MEMORANDUM

To: Planning Commission
 From: Community Development Department
 Subject: Rees Capital Office Site Plan Review
 1680 E. Dimple Dell Road
 [Community # 22]

Zone PO
 SPR-02-20-5798
 0.52 Acres

Project Name: Rees Capital Office
Plan Case Number: SPR-02-20-005798
Project Address: 1680 Dimple Dell Road

PROJECT NO: 2001005
SITE PLAN
CSP.01
4 OF 10

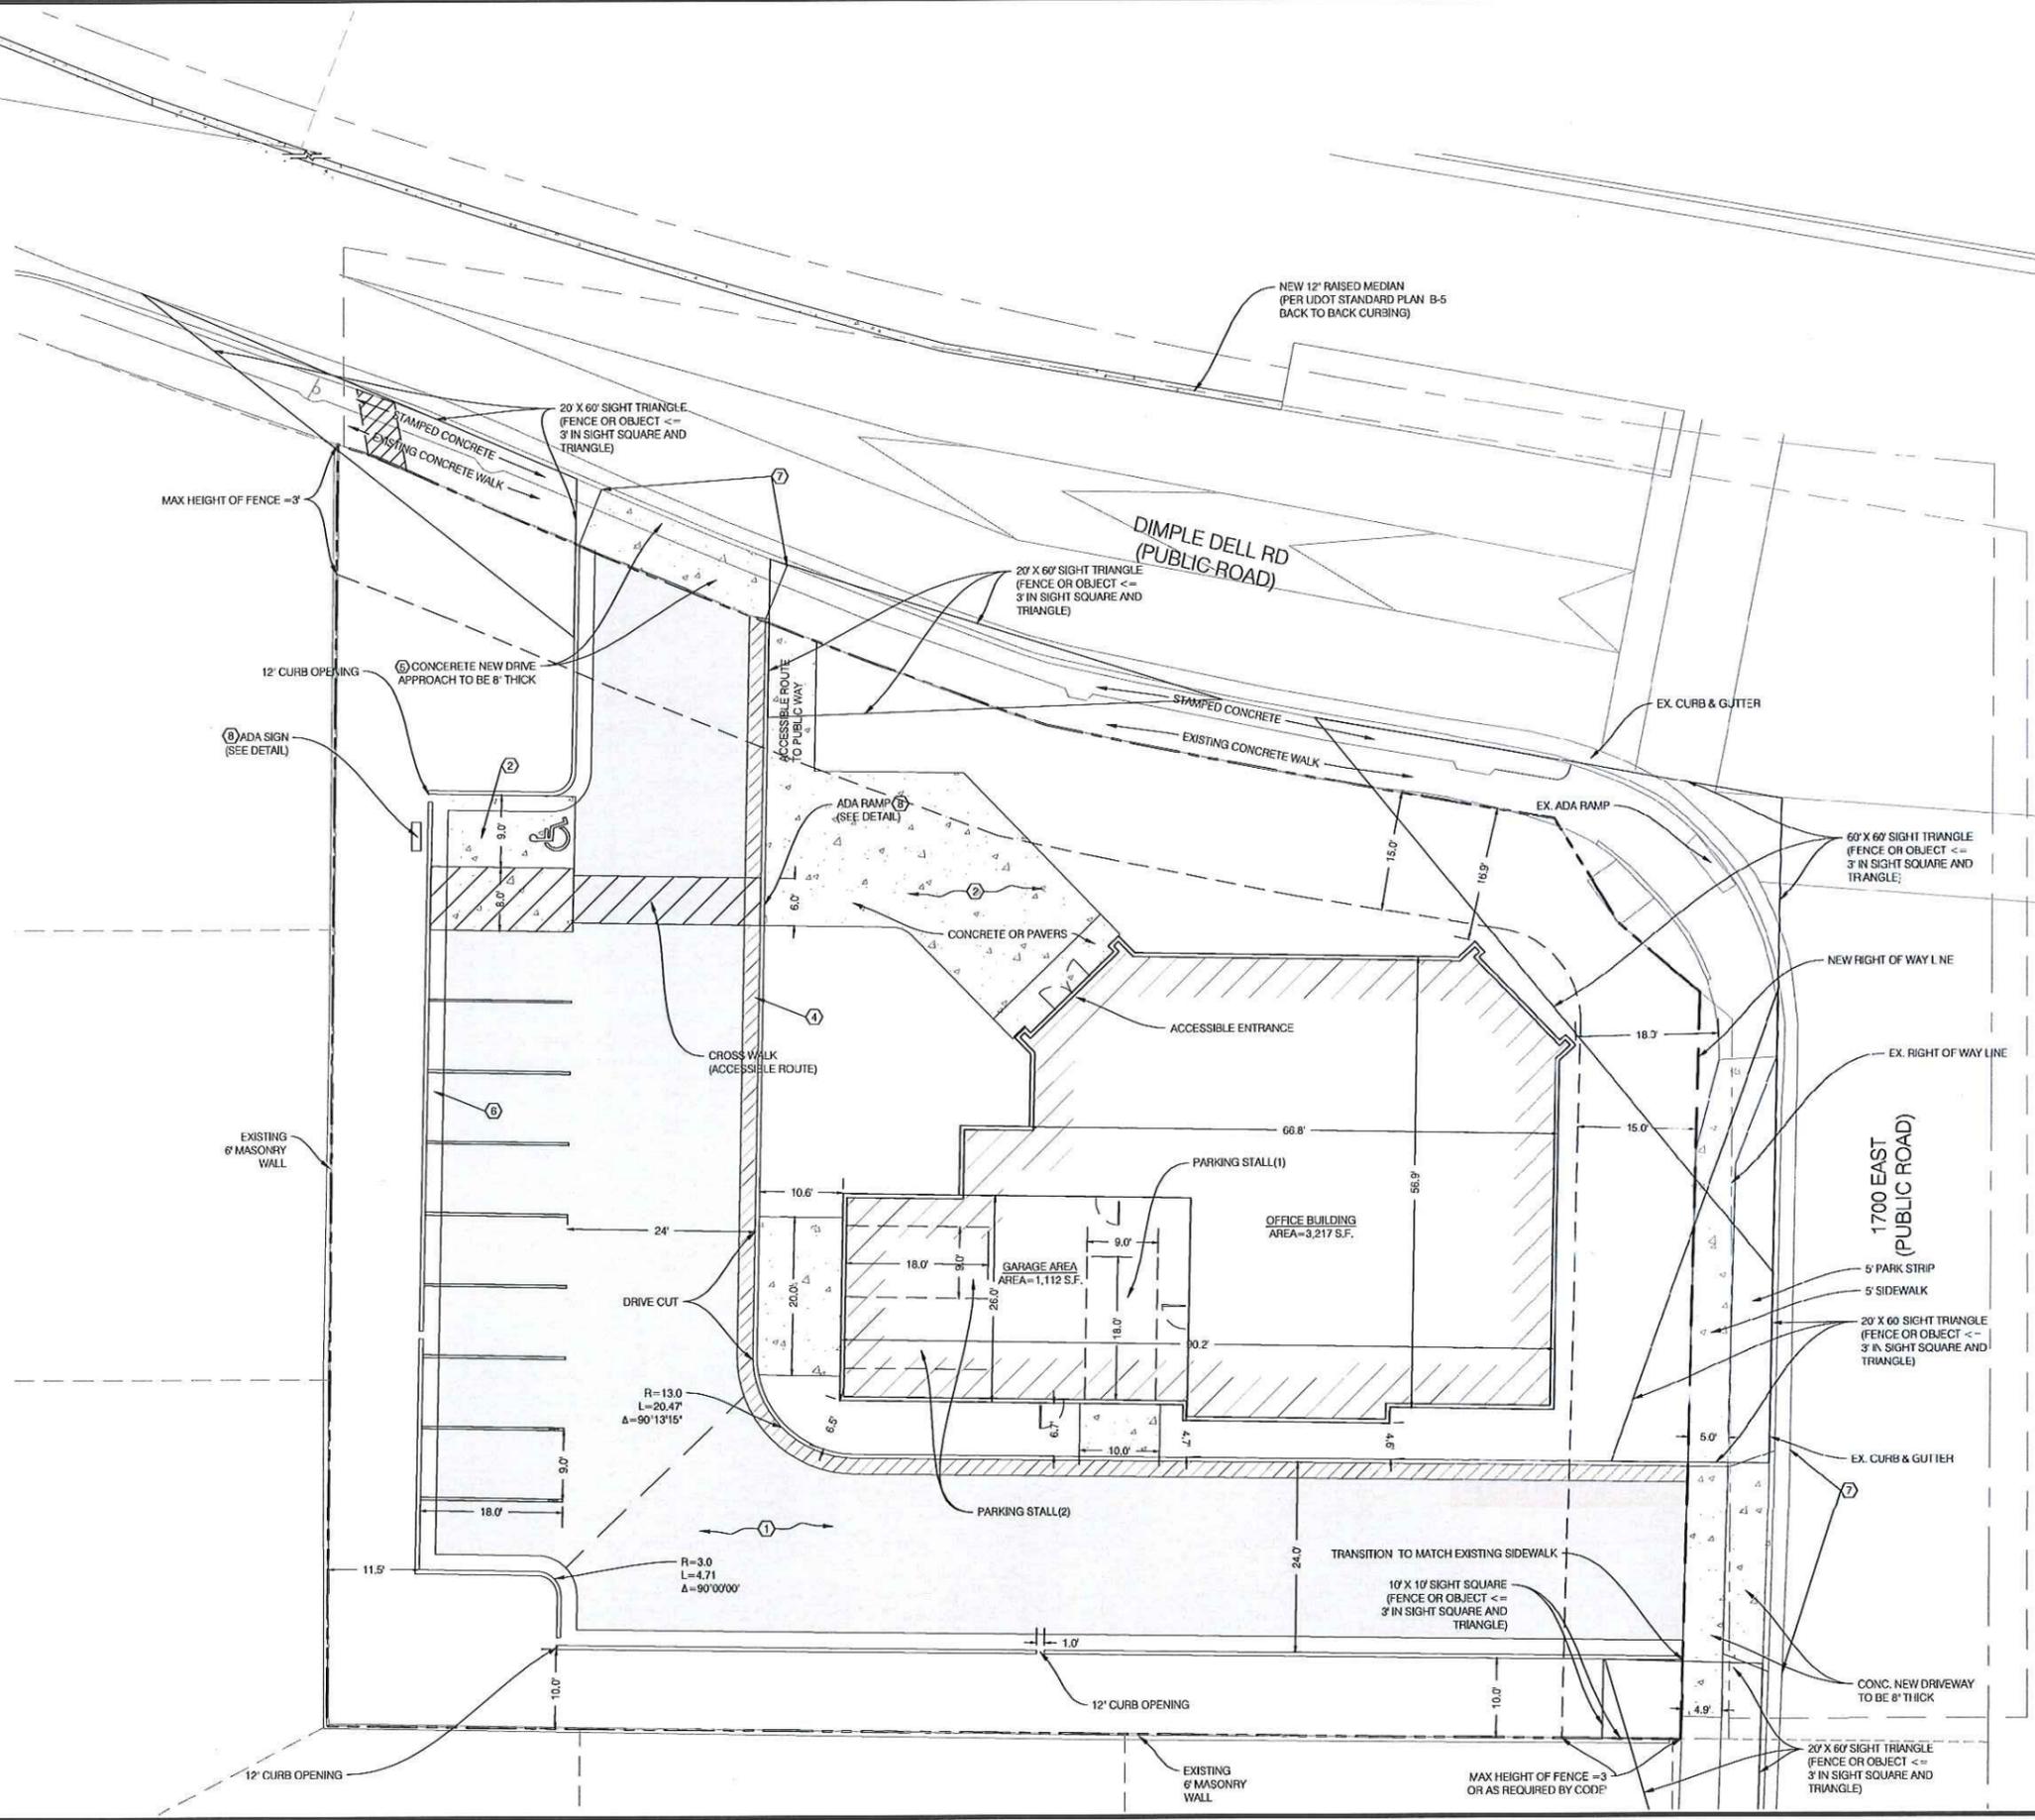
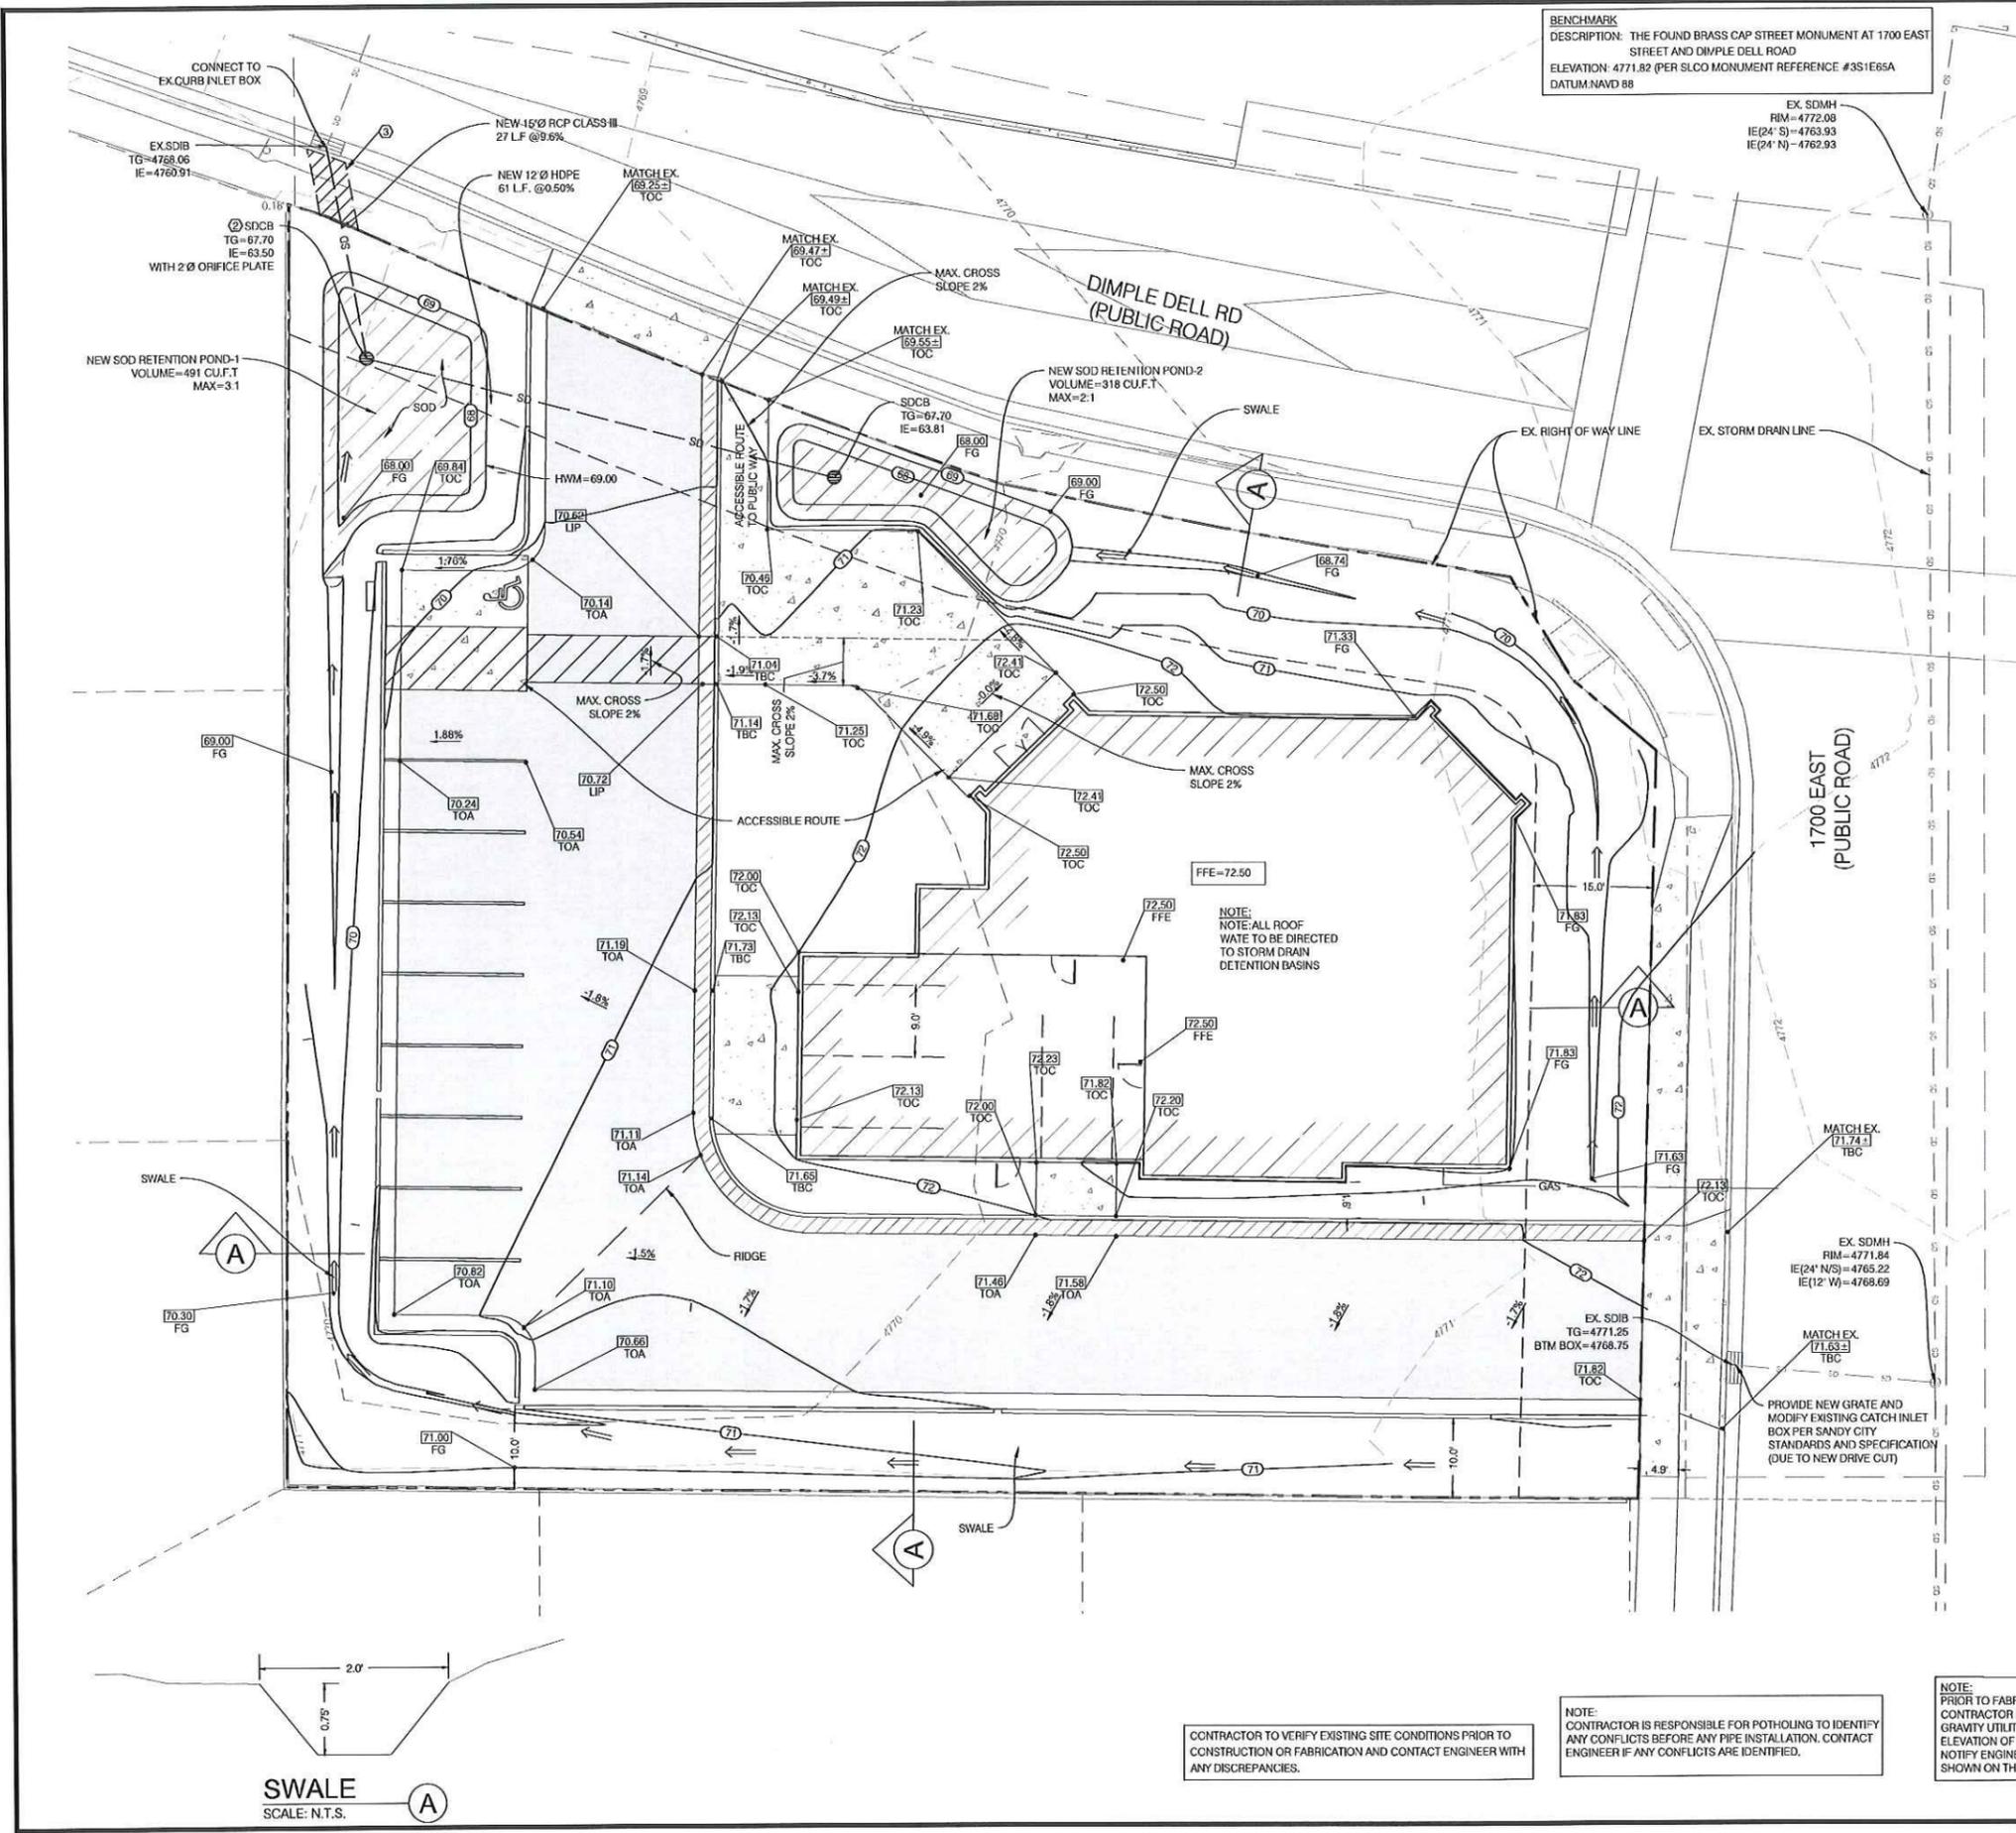
Landscaping. All the remaining vacant property on the site will be improved with required site improvements and landscaping, including the required 10 foot wide landscaped buffer area along the zone boundary between the residential and the professional office zoning. Landscaping is proposed to meet City requirements, **EXCEPT for the applicants request to not put street trees along the Dimple Dell Road or the 1700 East Street frontages. (Please see the applicant's attached justification letter.)**

Street Right-of-Way Dedication. Street right-of-way dedication is required on 1700 East Street to provide the new streetscape standard for the 5 foot wide landscaped park strip and the five foot wide sidewalk. The street dedication will occur through the subdivision plat. (See the Subdivision request also on this meeting agenda.)

Sandy City Development Code Section 21-25-02, Commercial and Industrial Landscape Requirements-A-3, Street Trees, states "Two inch caliper street trees shall be planted in the front parkstrip area...where the parkstrip is a minimum of eight feet in width, according to the varieties and spacing specified in the Sandy City Streetscape Plan. Where the park strip is less than eight feet in width or the sidewalk has been placed against the curb, street trees shall be planted 4 feet behind the sidewalk." Because of the clear sight triangles necessary for the new west driveway on Dimple Dell Road, and the intersection of 1700 East street and Dimple Dell Road, and the driveway on 1700 East street, wherein street trees are not allowed due to interference with the clear sight triangle area, only approximately 63 feet of street frontage is available for street tree planting on Dimple Dell Road, and only approximately 20 feet of street frontage is available on 1700 East. Within the 63 feet of street frontage on Dimple Dell Road staff would require the placement of between three and six street trees, placed at least 4 feet behind the sidewalk. On 1700 East Street, within the 20 feet staff would require 2 trees.

Since the proposed 25-foot curb cuts are in close proximity to the intersection of Dimple Dell and 1700 East, it may be considered a safety hazard for school buses, pedestrians and vehicle traffic.

3. That required street trees be installed along Dimple Dell Road in the 63 foot area outside the required clear sight triangles with either three trees spaced evenly along that street frontage or six trees, planted in an informal clumping design approved by planning staff. That 2 street trees be installed along the 1700 East Street frontage.

C1 NORTH ELEVATION
A201A 1/4" = 1'-0"

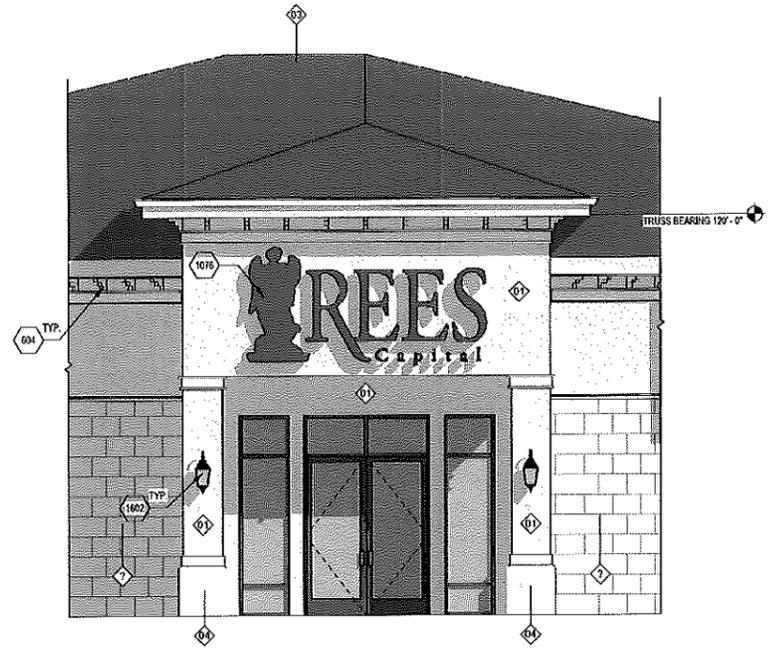
Building Architectural Design, Materials & Colors. The building architectural design, materials and colors meet the requirements of the Sandy City Architectural Design Standards, **EXCEPT for the percentage limit on stucco/EIFS being less than 20 percent on three of the four sides of the proposed building. (See the applicant's attached justification letter.)**

- Requesting that the Planning Commission approve the exterior building materials to include the use of Stucco/EIFS in excess of the code requirement of less than 20 percent per each of three of the four building faces. Percentages range from 25 to 34 percent stucco/EIFS.
- Requesting that the Planning Commission determine that the use of garage doors on two sides of the attached garage exceed the height of normal residential garage doors, up to 14 feet in height.
- Requesting the Planning Commission to not require street trees to be installed along Dimple Dell Road or along 1700 East Street.

Staff's Issues with Requested Deviations from the Sandy City Code. Staff supports the applicant's proposal to use higher value Terro Neo type stucco/EIFS in excess of the 20 percent per building face on three of the four building elevations. The use of Terro Neo has been approved by the Planning Commission on numerous occasions and if properly installed, has the appearance of large sheets of natural cut stone.

7. That the architectural design, colors and materials proposed for this development and as approved by the Planning Commission as complying with the Sandy City Architectural Design Standards be finalized with staff prior to the issuance of a building permit, including the use of Terro Neo type stucco/EIFS in excess of 20 percent per building face, as shown on the architectural elevations of the building.
